HERSCHEL/PLANCK

REF.: H-P-ASP-MN-3961

SPIRE Progress & Interface

SPIRE Progress & Interface Meeting

Level 0 Thermal Straps – Drawing

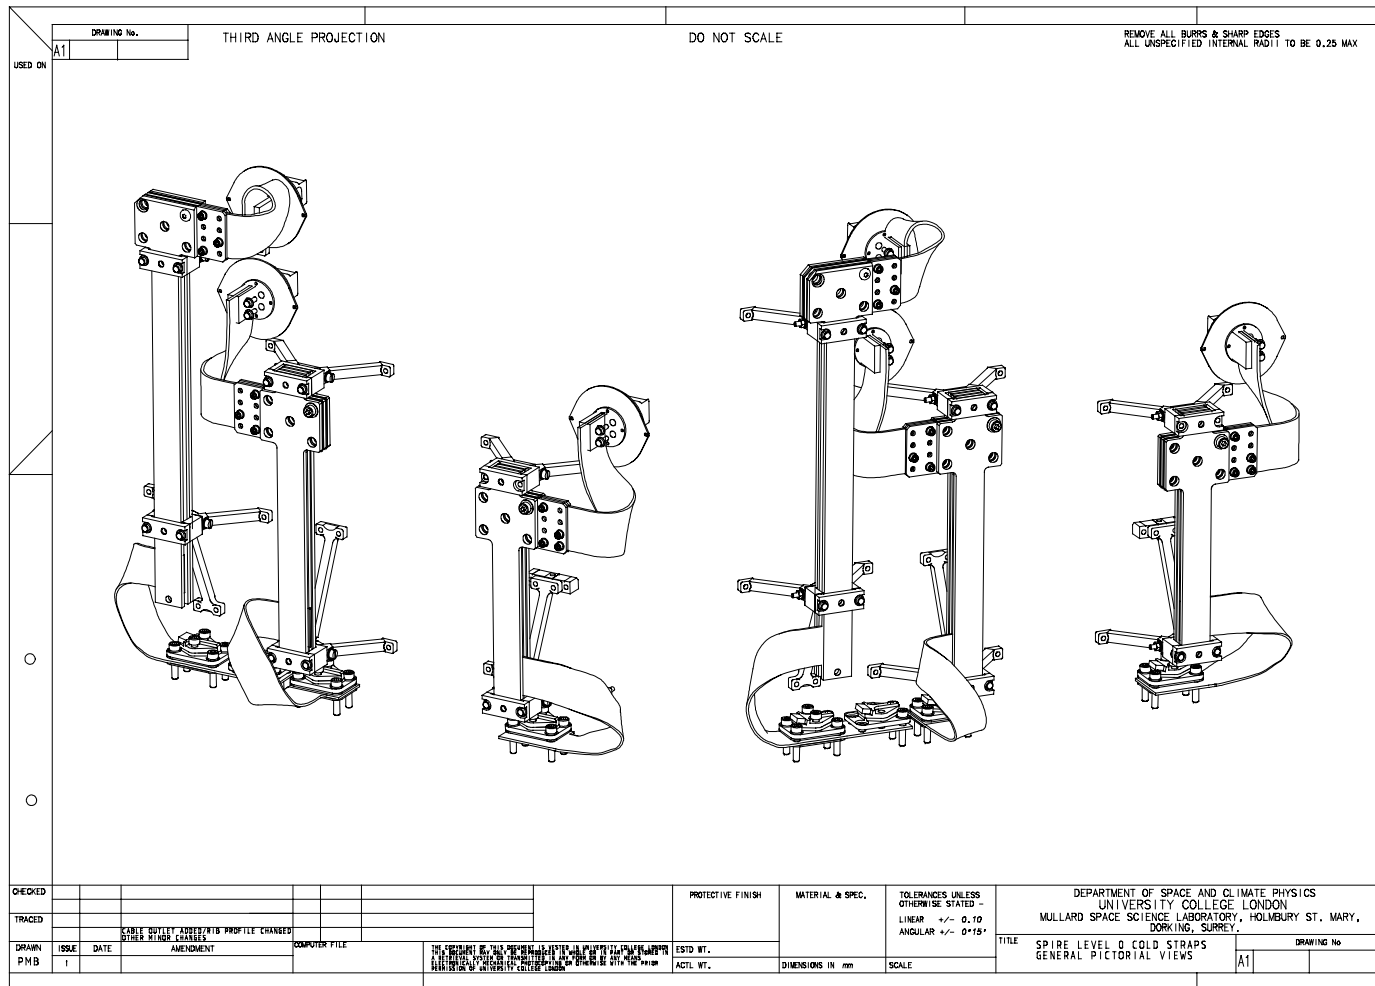
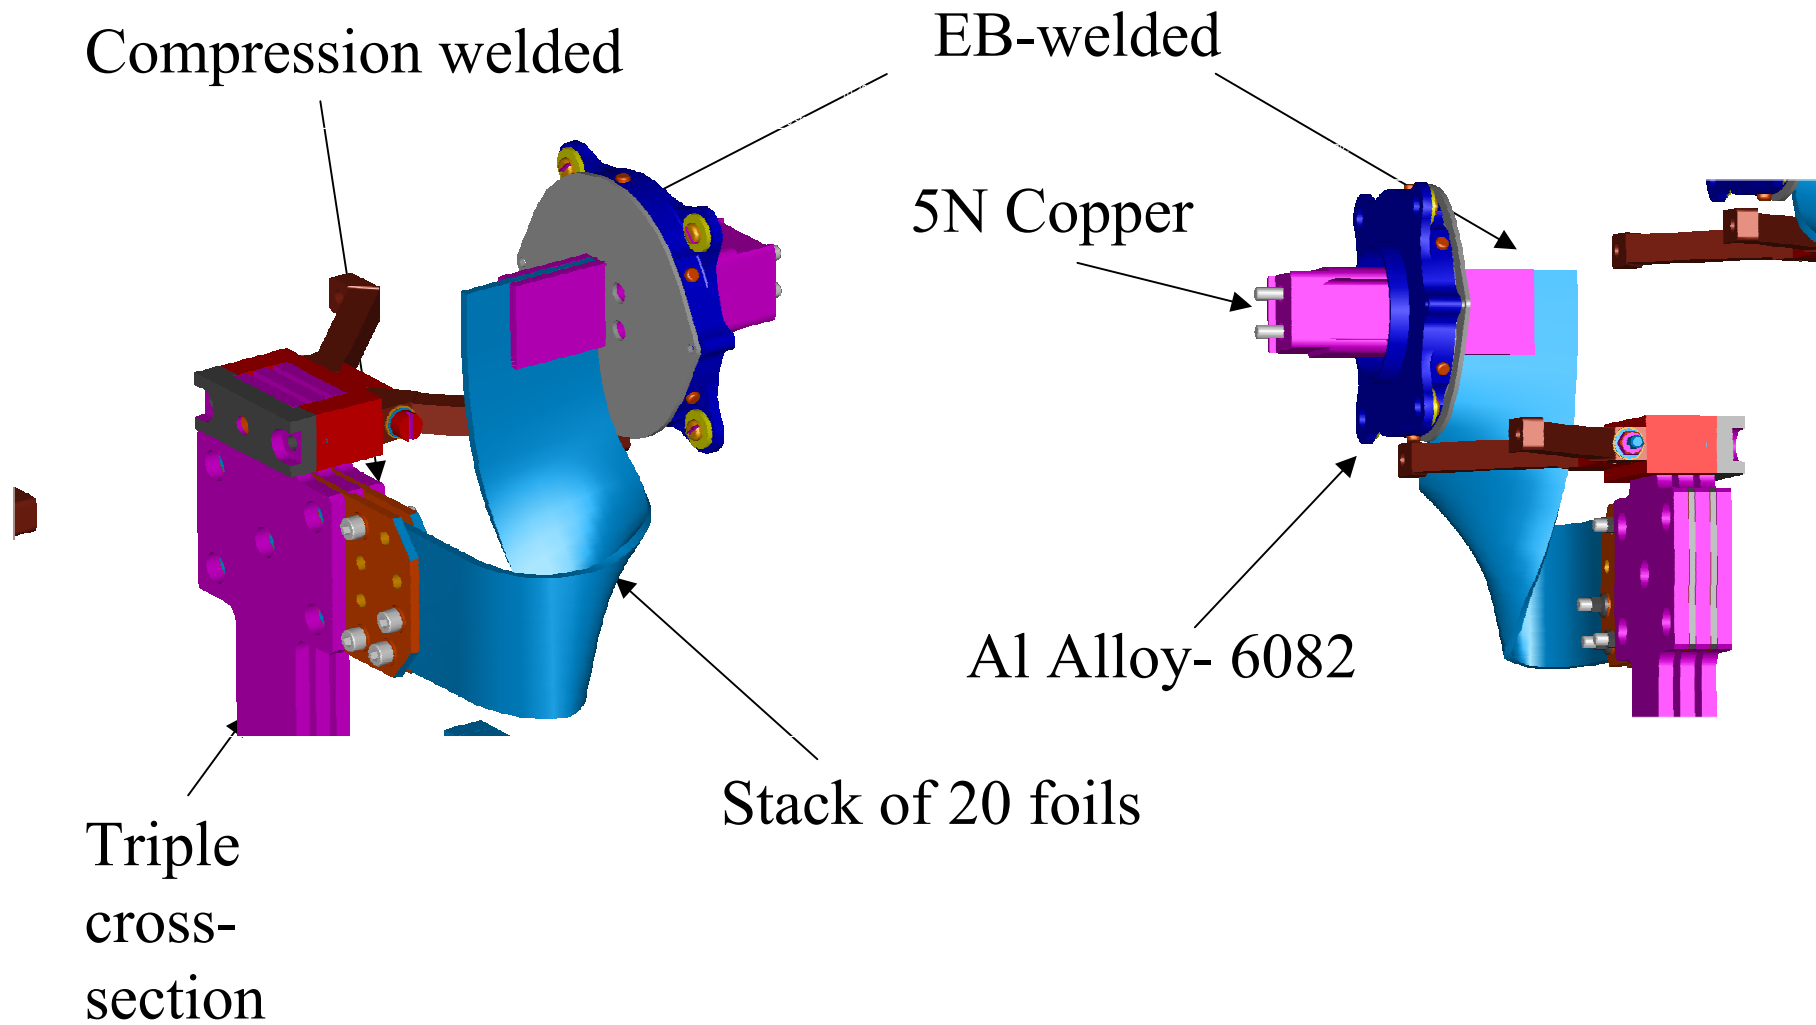
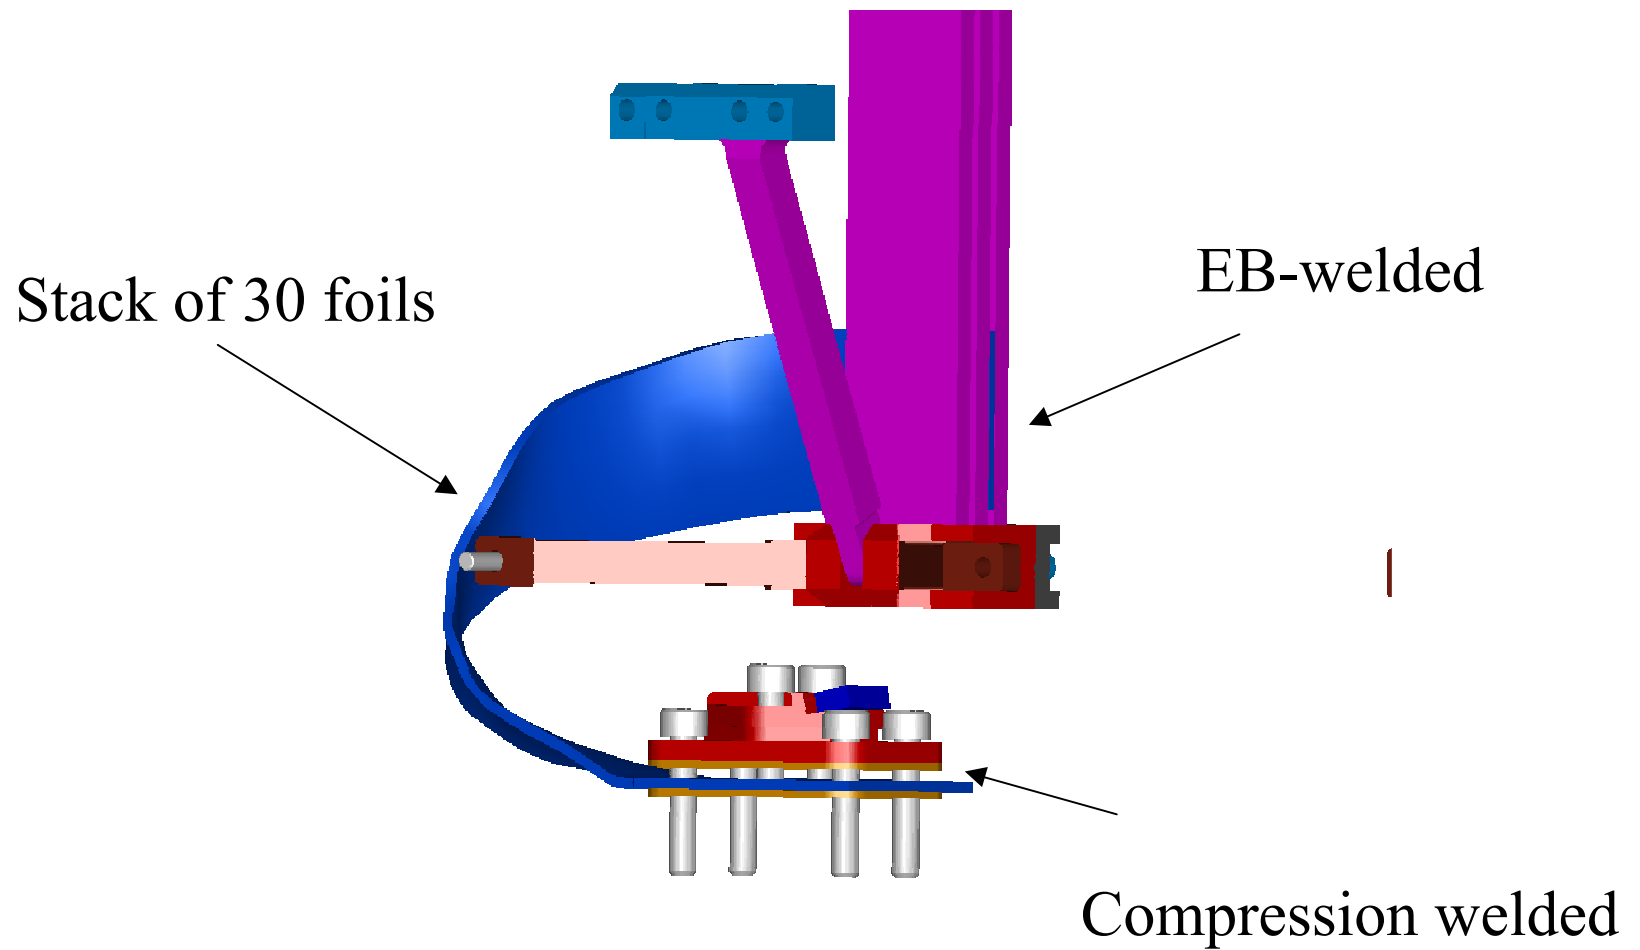
Thermal straps have been modified between Level 0 interface and SPIRE FPU to improve the conductance

Open issues: Clearance between level 0 and vent line is now solved (MSSL working with the latest CAD model).

One of the 4 screws of the Pump strap interface appears to be difficult to install because of the SPIRE strap support frame. MSSL states that there is no time / money to update this, and proposes that this should be handled by dismantling the A frame.

The effective suspended mass of the SPIRE strap which is attached to the cooler heat switch is currently estimated to 140g.

**PODS Bolt pattern (Astrium)
(2 sheets)**

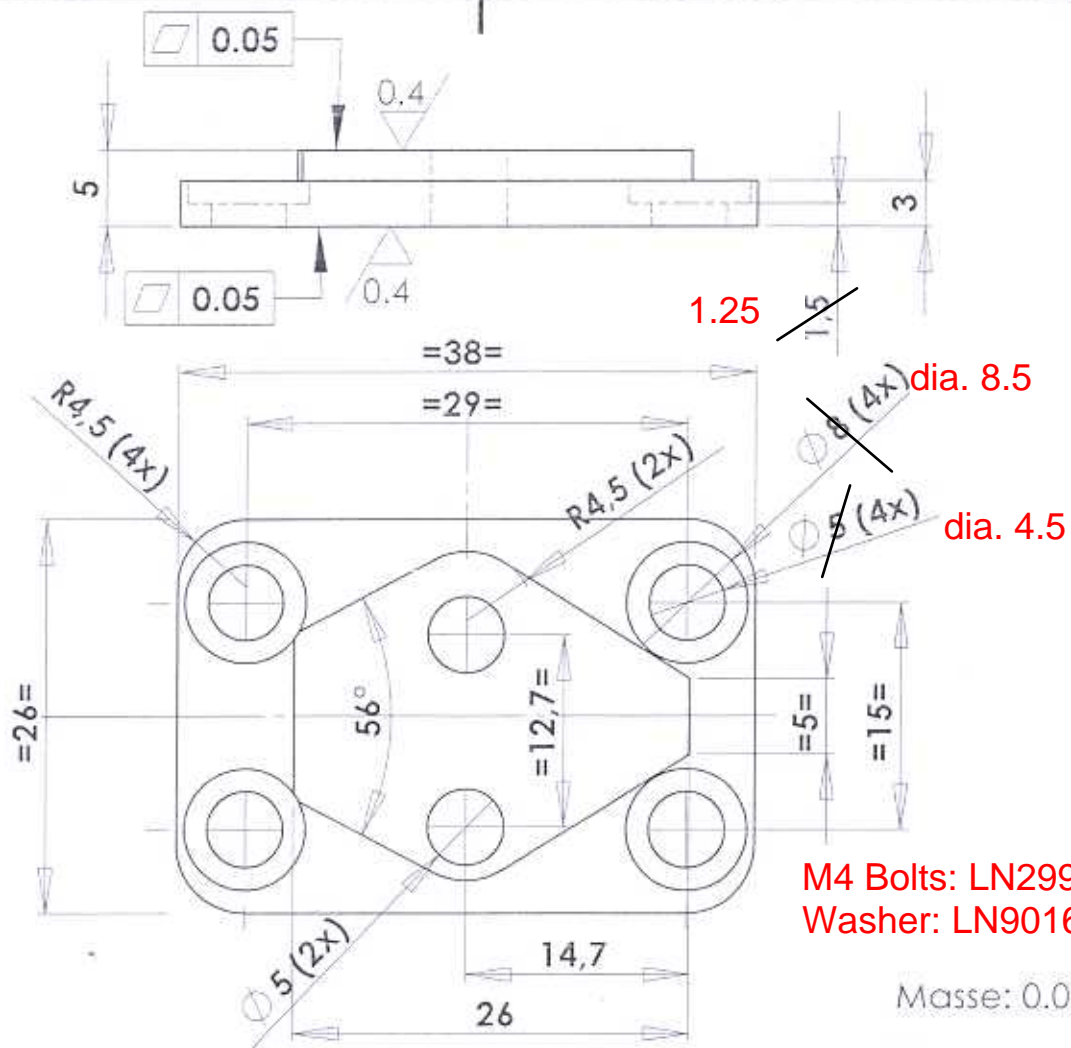
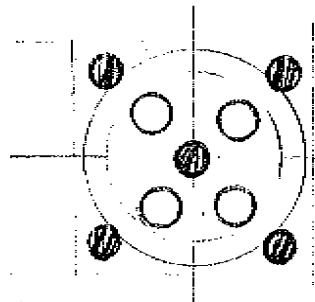
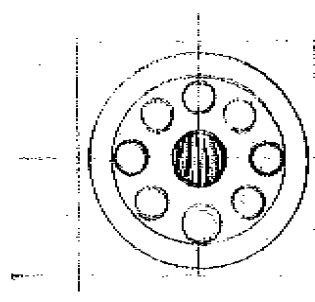
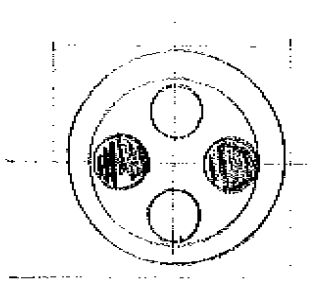
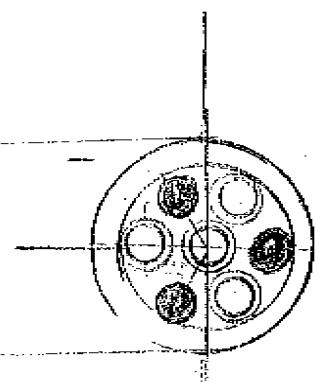
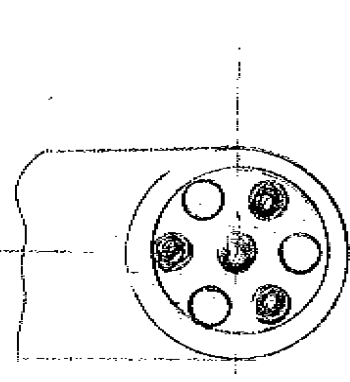
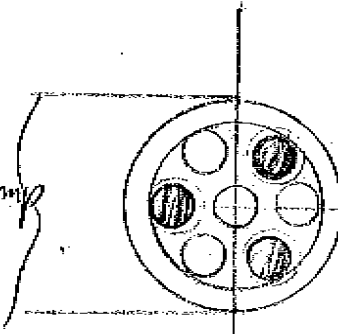
Closed Pod: 4 tapped holes for strap + 2 for T sensor (see annex 4)

Design of the "Open pods" in not fully frozen. (Square + 1 central hole)

Design of the Open Pod bolt pattern should be frozen in the next 2 weeks, by agreement with SPIRE/MSSL.
